April 3, 2024

IDEA Public Schools Upper RGV Mechanical Upgrades CSP#23-URMU-0424

ADDENDUM NO. 2

02 IDEA MISSION BUILDING C ENLARGED MECHANICAL & ELECTRICAL FLOOR PLAN
 SCALE: 3/8" = 1'-0"

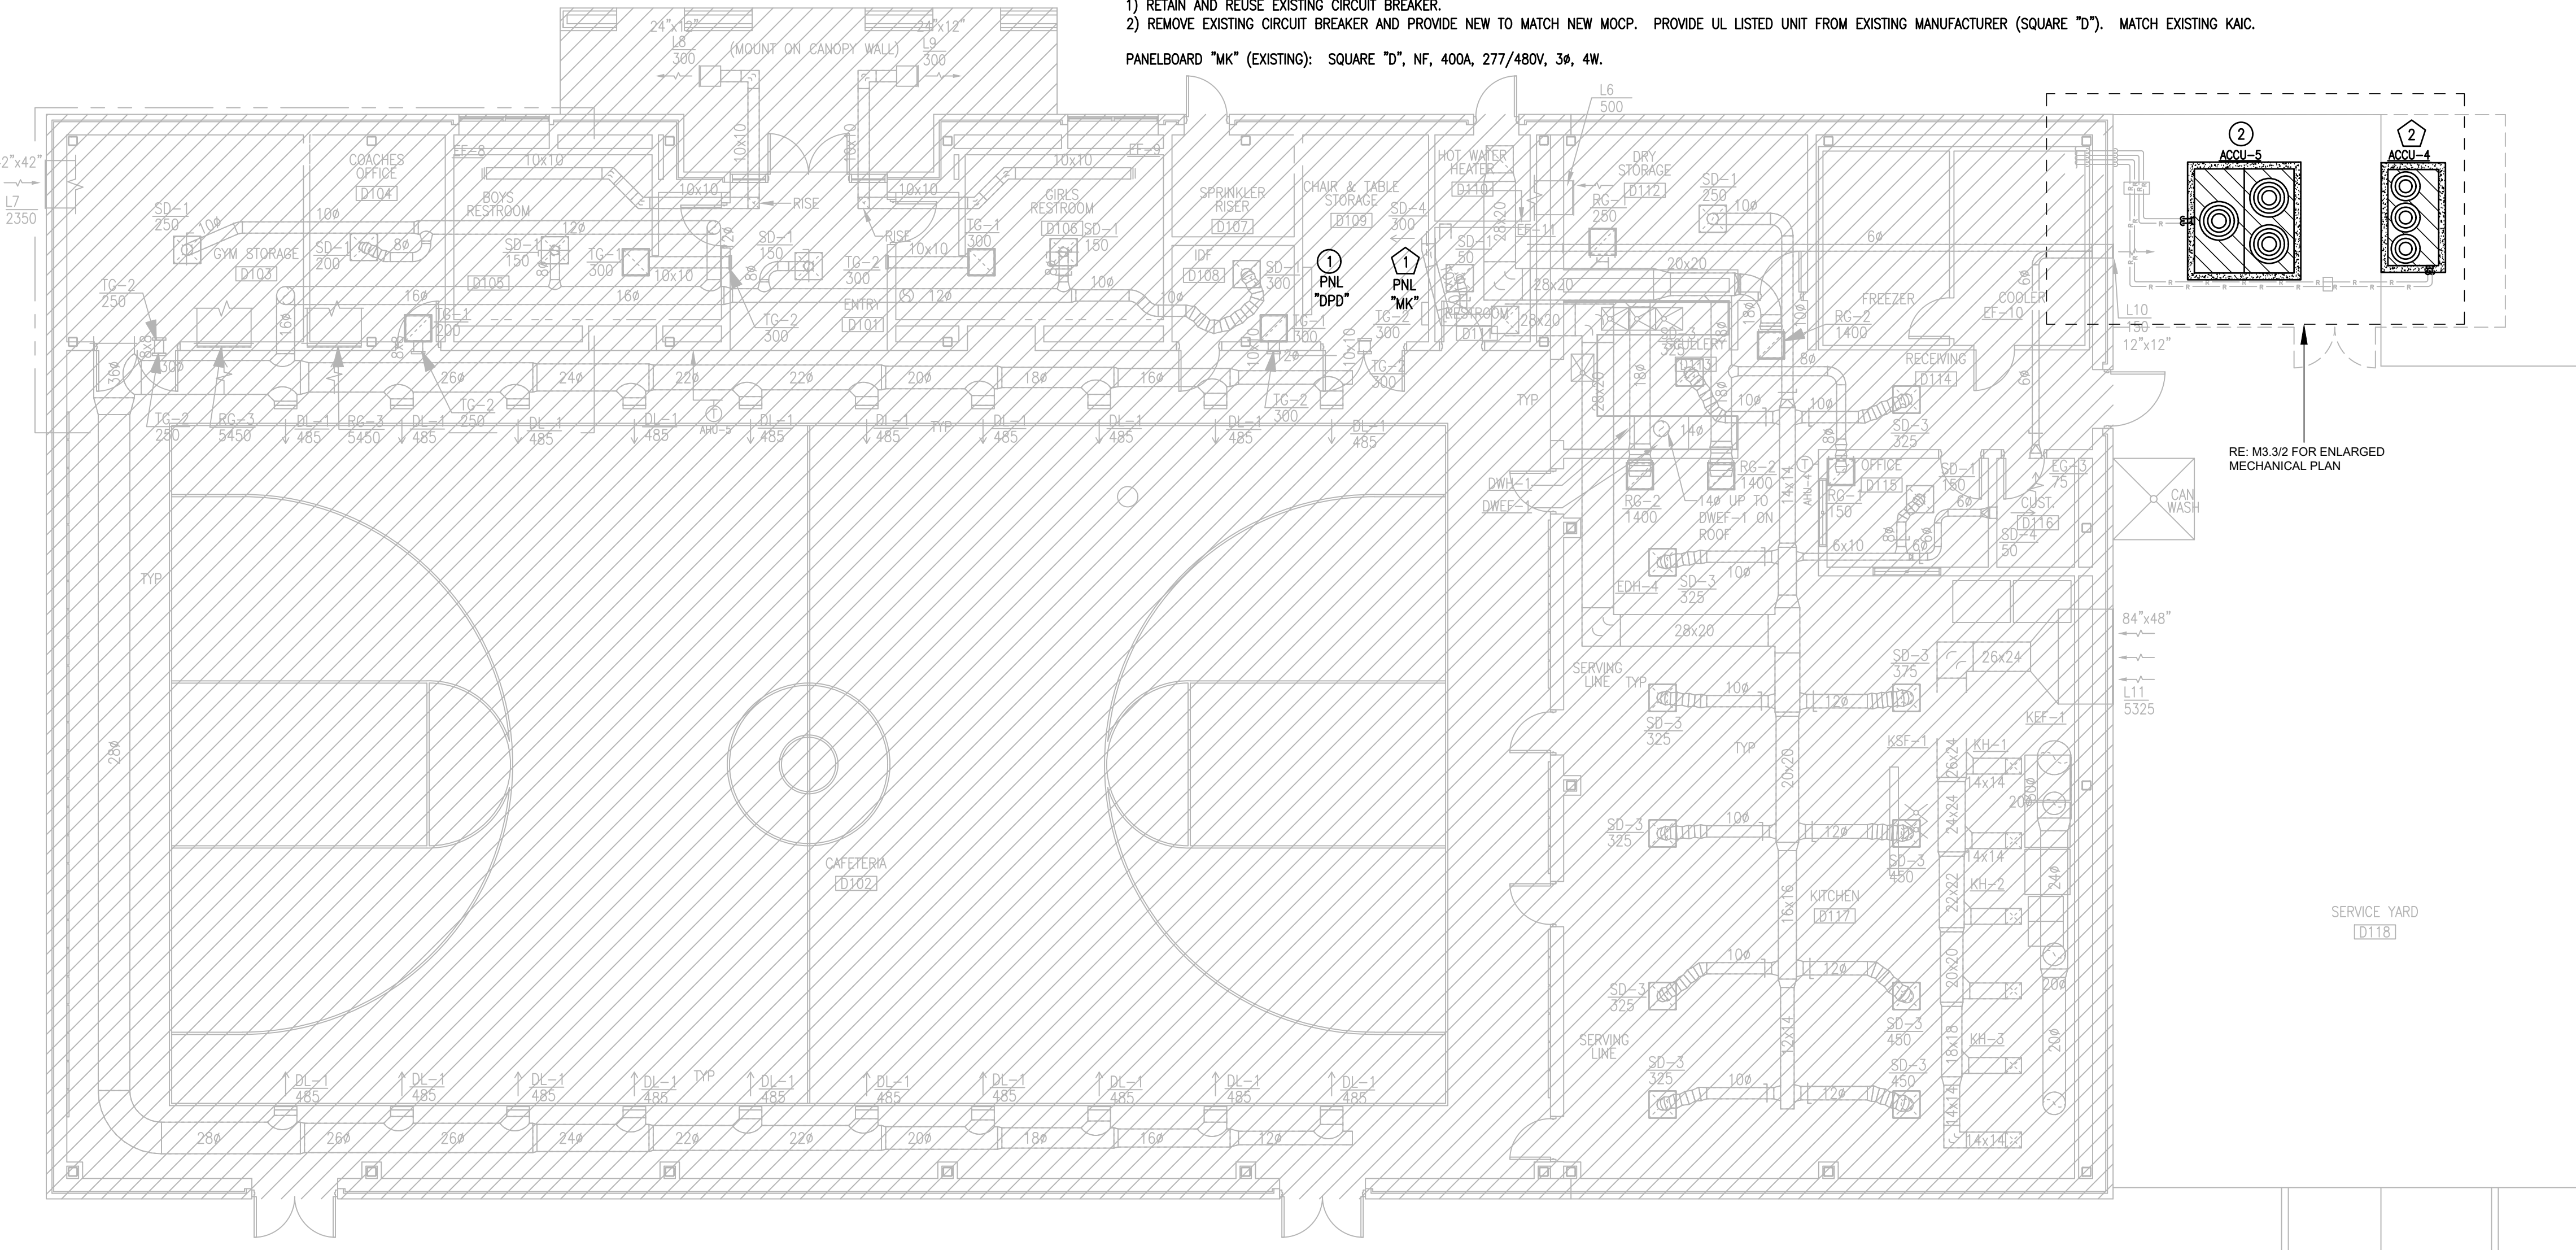
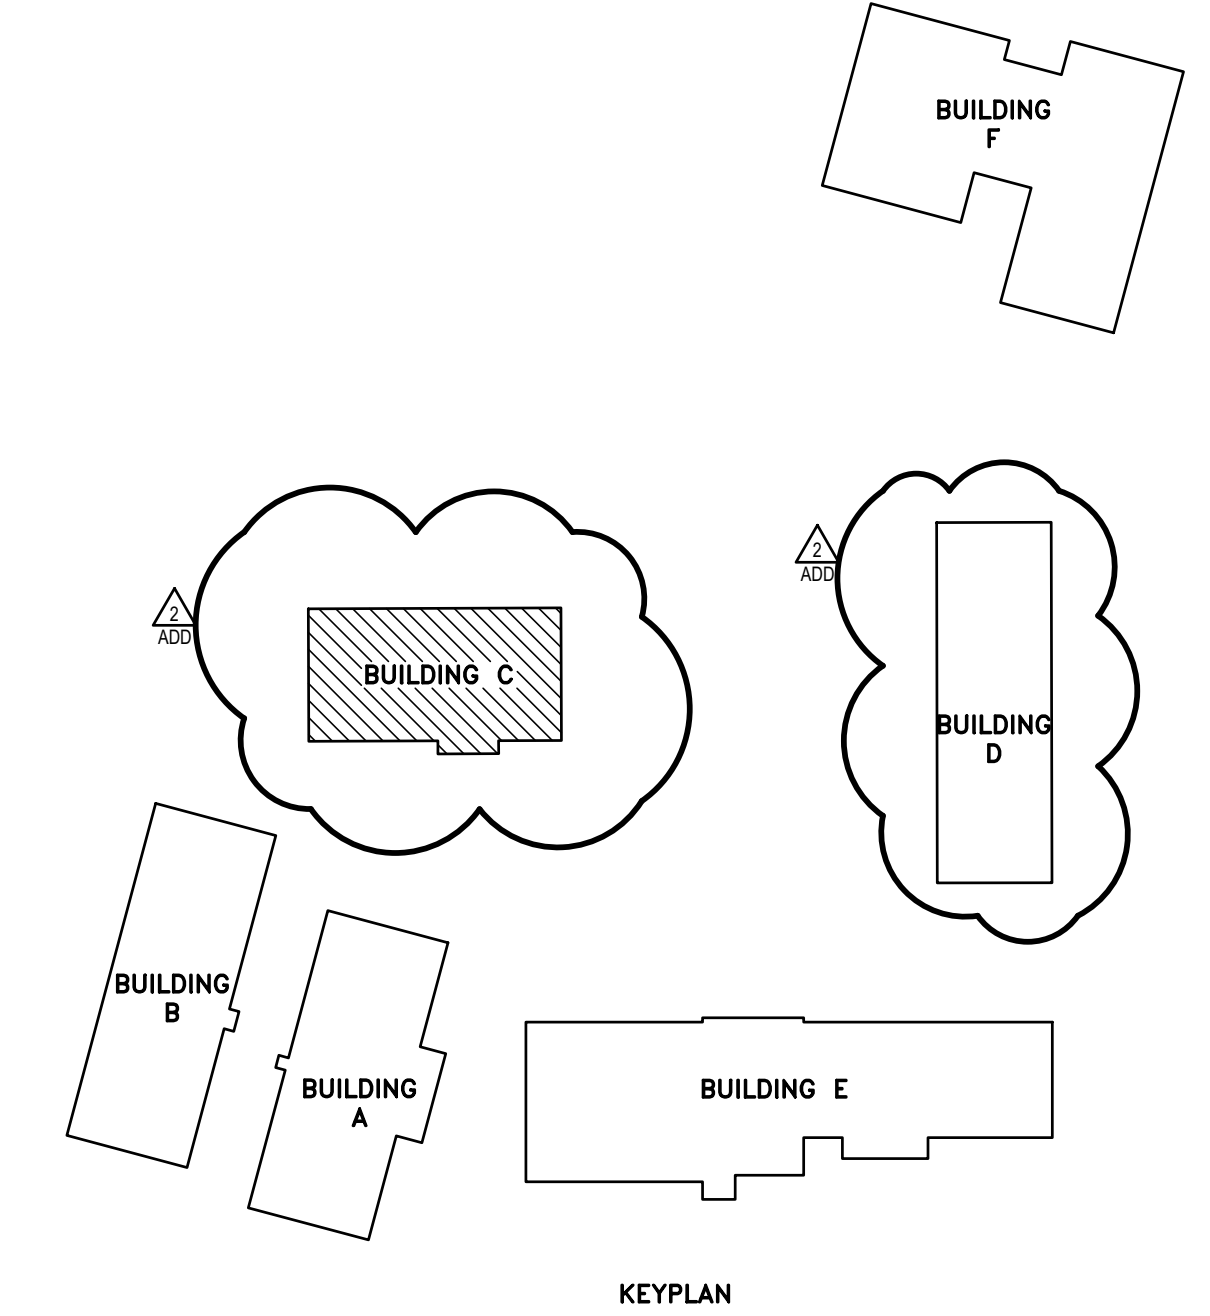
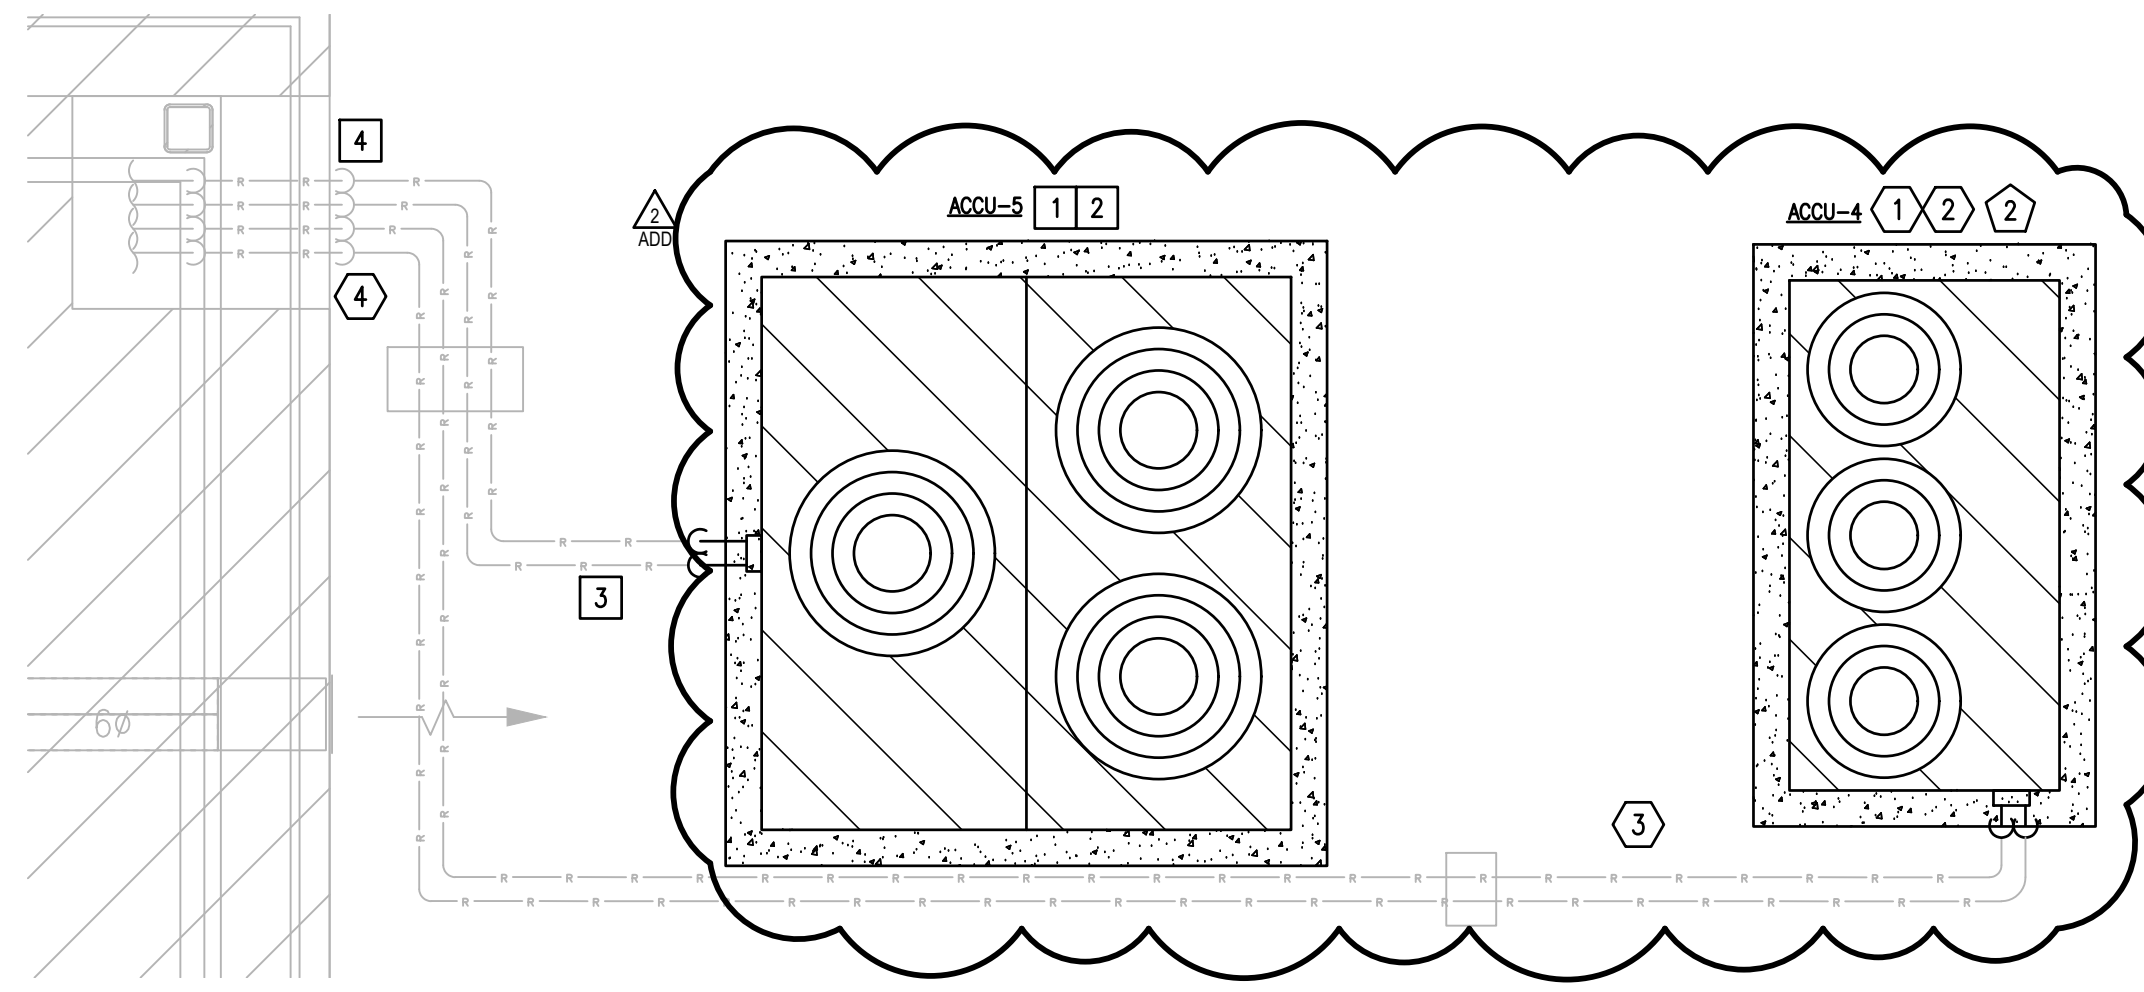
5. Sheet ME-3.3 – See attached.
 - a) Added Base Bid identification to schedules.
 - b) Updated keyplan.
 - c) Calling for new housekeeping concrete pads.

- 2) DEMOLISH EXISTING AIR COOLED CONDENSING UNIT. PROVIDE NEW AIR COOLED CONDENSING UNIT AND INSULATE REFRIGERANT PIPING PER SPECIFICATIONS. MAINTAIN MANUFACTURER'S RECOMMENDED CLEARANCES AND PROVIDE NEW 4" TALL HOUSEKEEPING CONCRETE PAD FOR NEW EQUIPMENT. PAD SHALL BE MINIMUM 6" LARGER THAN EQUIPMENT FOOTPRINT ON ALL SIDES. REFRIGERANT PIPING SHOWN IS STRICTLY SCHEMATIC. VERIFY NUMBER OF CIRCUITS AND PIPE SIZES WITH MANUFACTURER'S DATA. BOLT EQUIPMENT DOWN TO CONCRETE SLAB. ATTACHMENT SHALL BE CAPABLE OF WITHSTANDING THE LOCAL WIND PRESSURES.
